**FEDERAL HIGHWAY ADMINISTRATION
FINDING OF NO SIGNIFICANT IMPACT
FOR**

Columbus Viaducts Project
Platte County, Nebraska

FINAL ENVIRONMENTAL ASSESSMENT

SUMMARY FINAL ENVIRONMENTAL ASSESSMENT – ERRATA TO DEA

DATE	June 2011
FIGURE	3-4

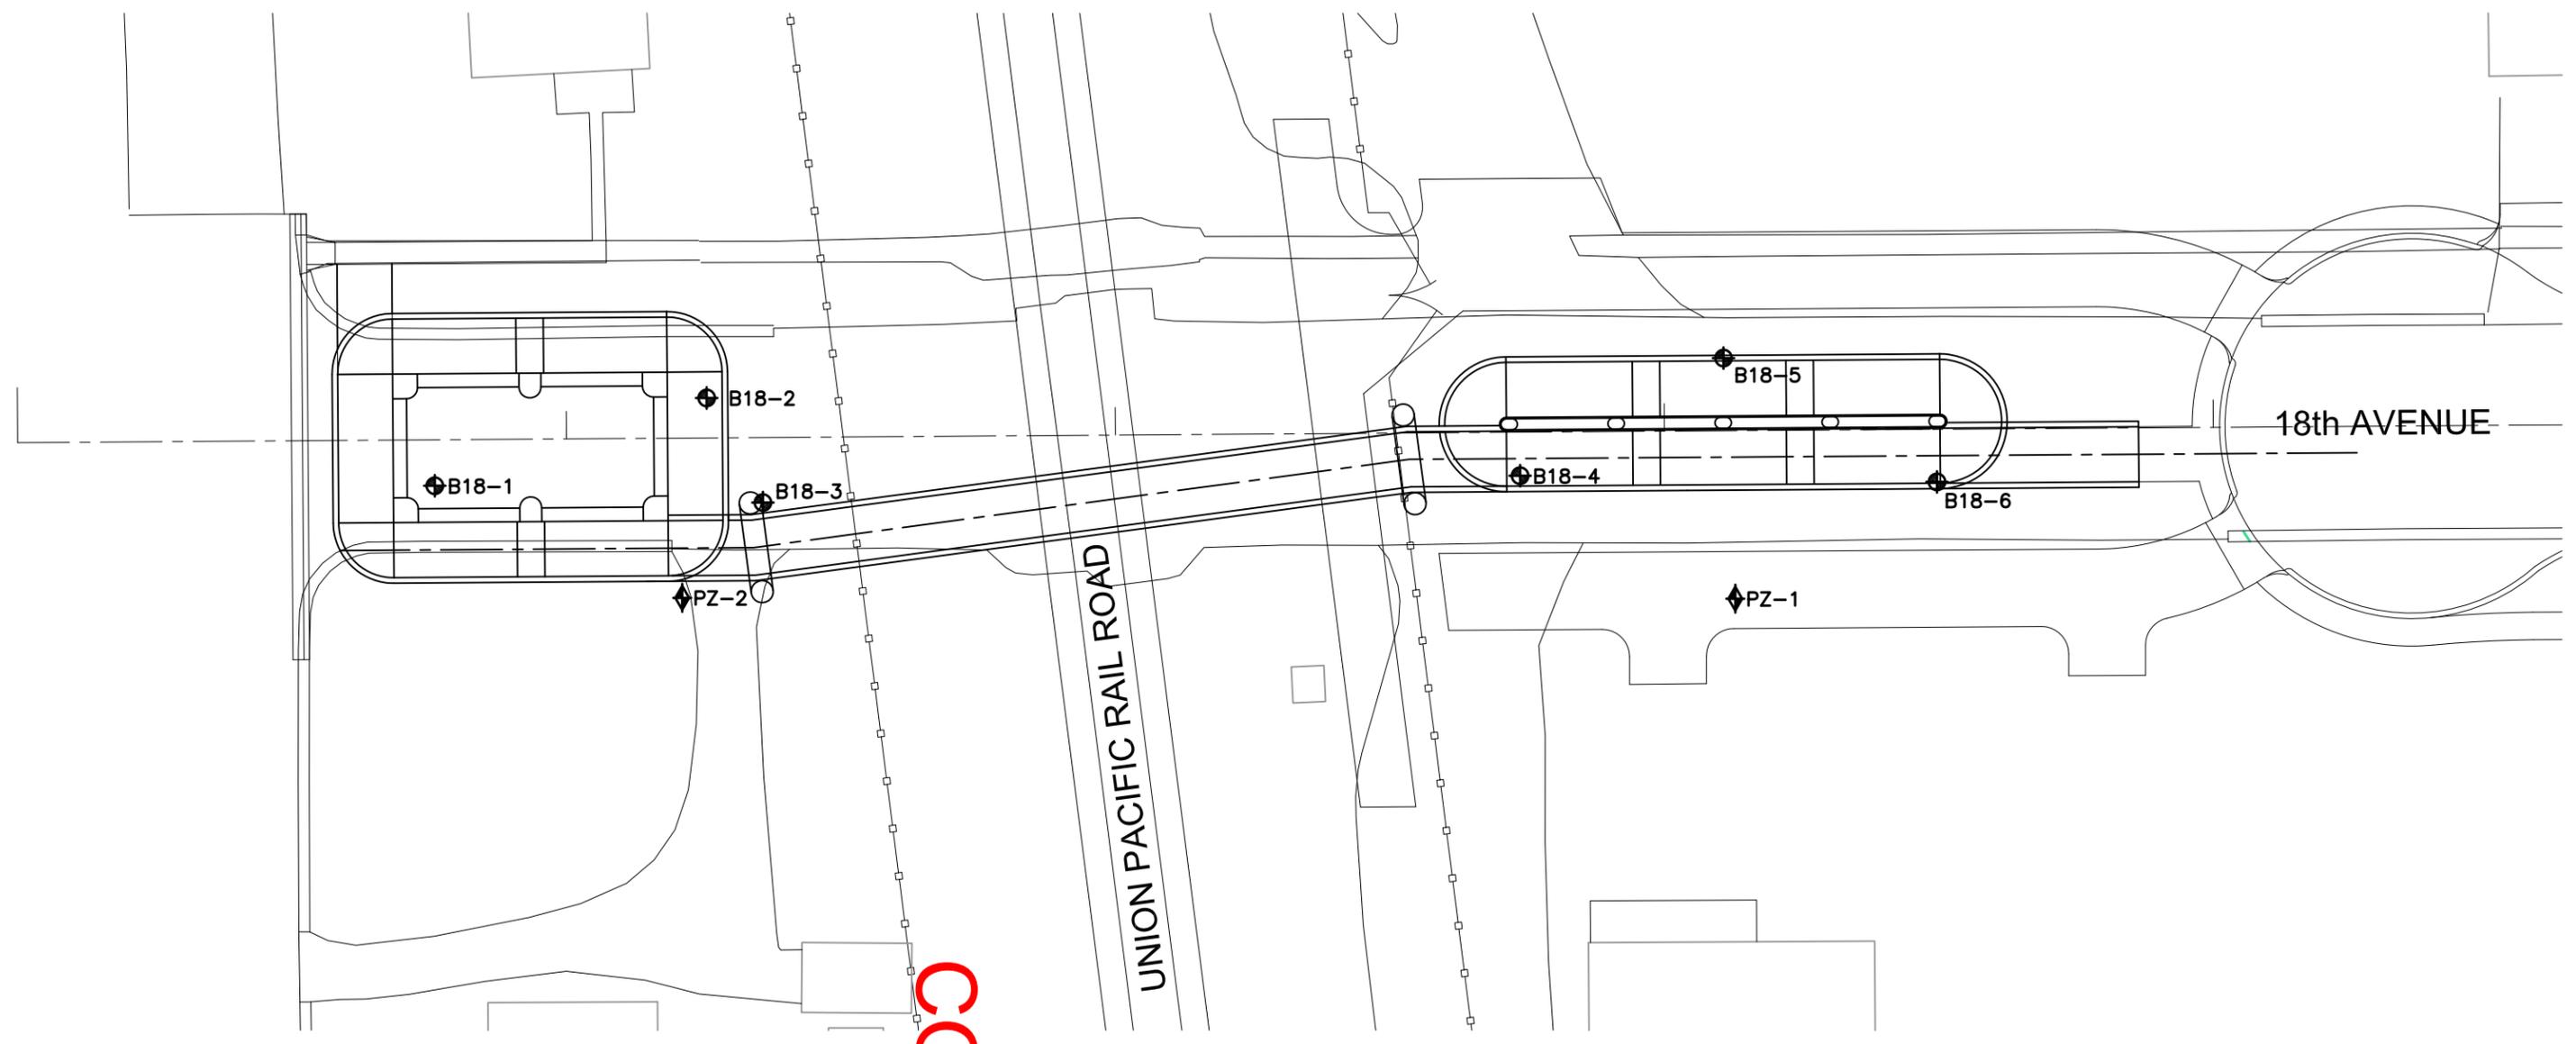
Figure 3-4 was updated using 2010 aerial photos that show the additional buildings constructed along 3rd Avenue for Deckert Enterprises LLC and Viking Storage. Impacts to these businesses are discussed under revisions to Section 3.9.3, Impacts of Build Alternative [Economics].

Figure 2.12
"A" Level Wells
cis-1,2-DCE Plume
Shallow Aquifer
October 2010

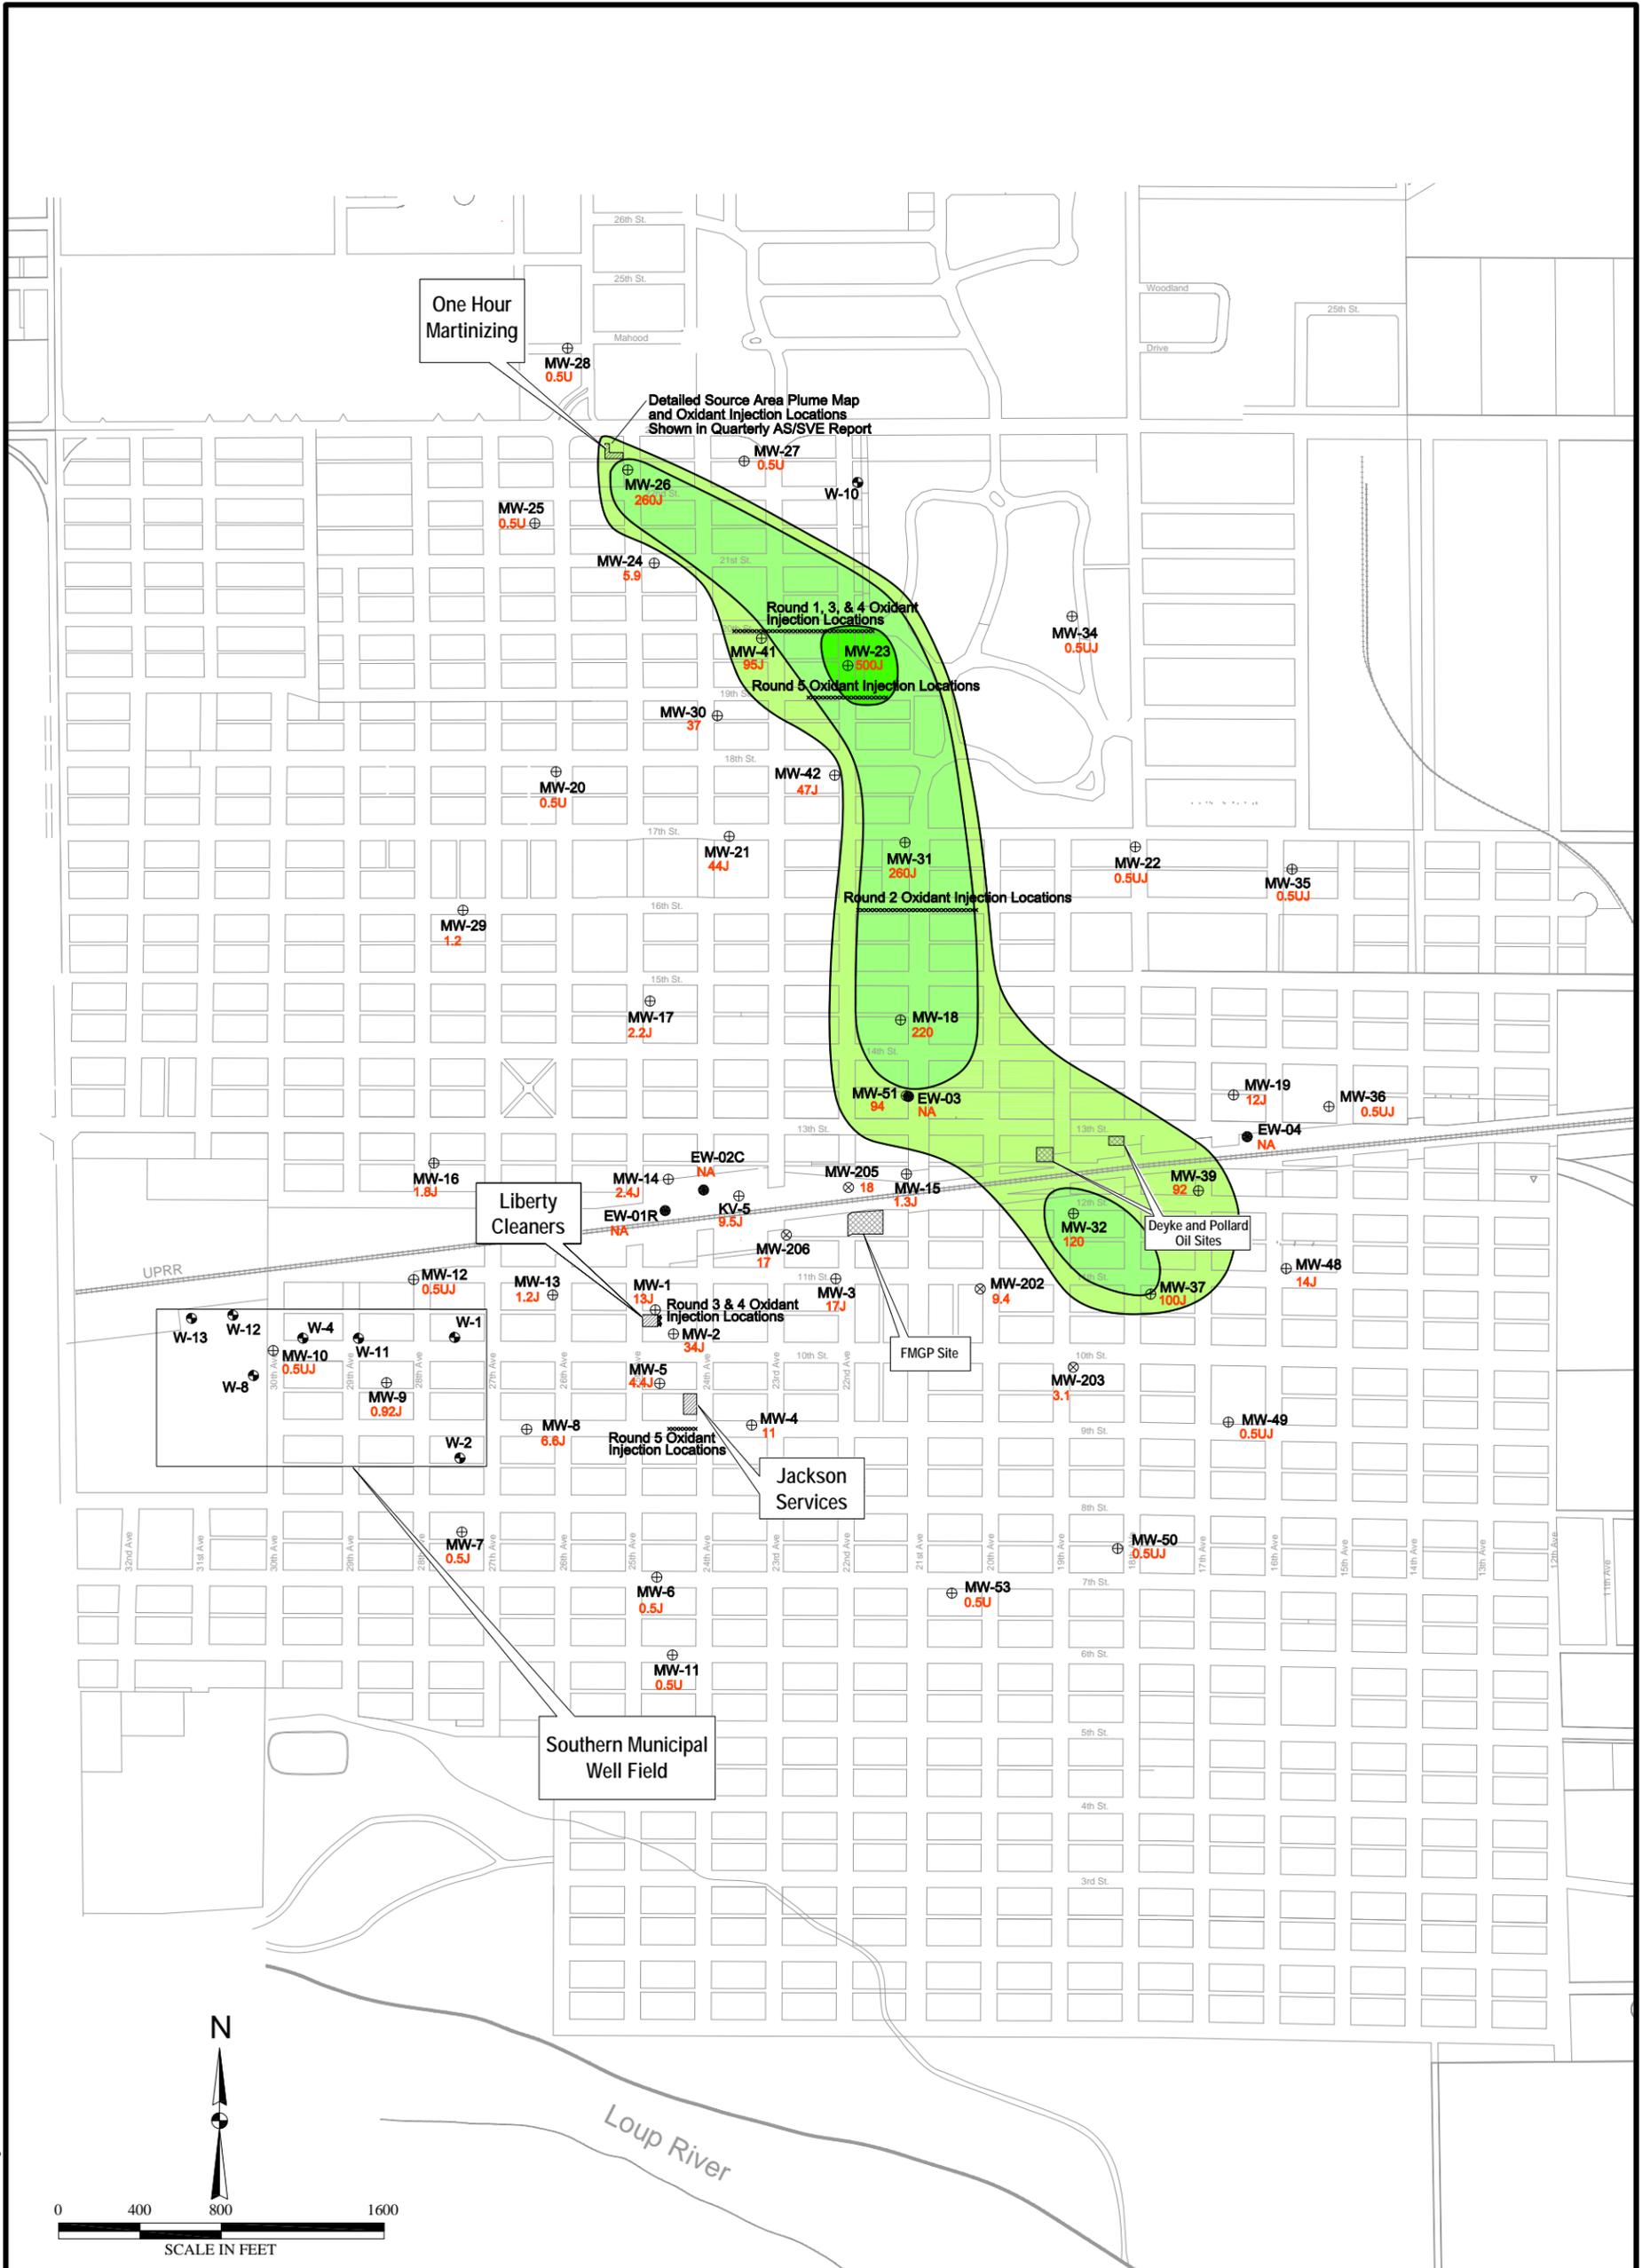
3. In regard to your reported groundwater results for cis 1,2 dichloroethene (cis 1,2 DCE) at PZ-2 of 39 ug/L, the EPA data from nearby monitoring wells that were sampled in October 2010, contained concentrations of cis 1,2 DCE between 92 and 120 ug/L. These results indicated that cis 1,2 DCE is present in shallow groundwater at concentrations that exceed the MCL of 70 ug/L in this area. This is the basis for the EPA's request to place the pilings at as shallow depth as possible to limit migration of contaminants into the deeper groundwater. Please refer to the enclosed Figure 2.12 which shows the October 2010, cis 1,2 DCE data.
